## Mack Chassis - Granite Models (GU, GR) - Revised Fan Ring Design; Engine Cooling Fan Ring Cracked At Welds - Model Years 2016 To 2020

Affected date ranges: 2 June 2014 (W1423) - 24 June 2019 (W1921)

### Correct Setting of the Fan Ring Seal

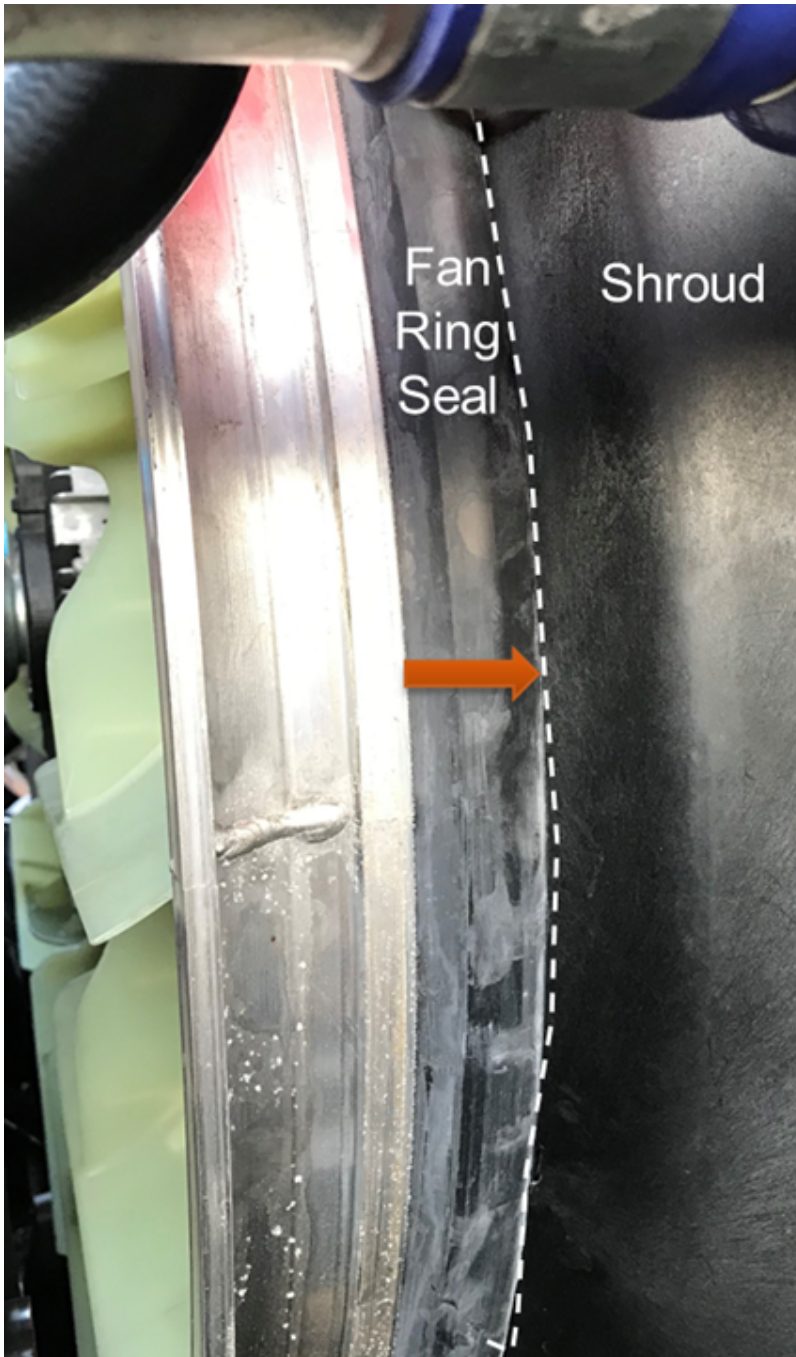
A new fan ring design has been released to address the vibration. The revised fan rings have been designed with a larger rubber seal that contacts the fan shroud and is able to effectively dampen vibration of the ring.

The seal should be outside of the shroud

**Correct** - Fan Ring Seal sits on the outside of the shroud

**Incorrect** - Fan Ring Seal is tucked INSIDE of the shroud causing it to look short in length. Be sure to check all the way around the shroud for mis-set seal
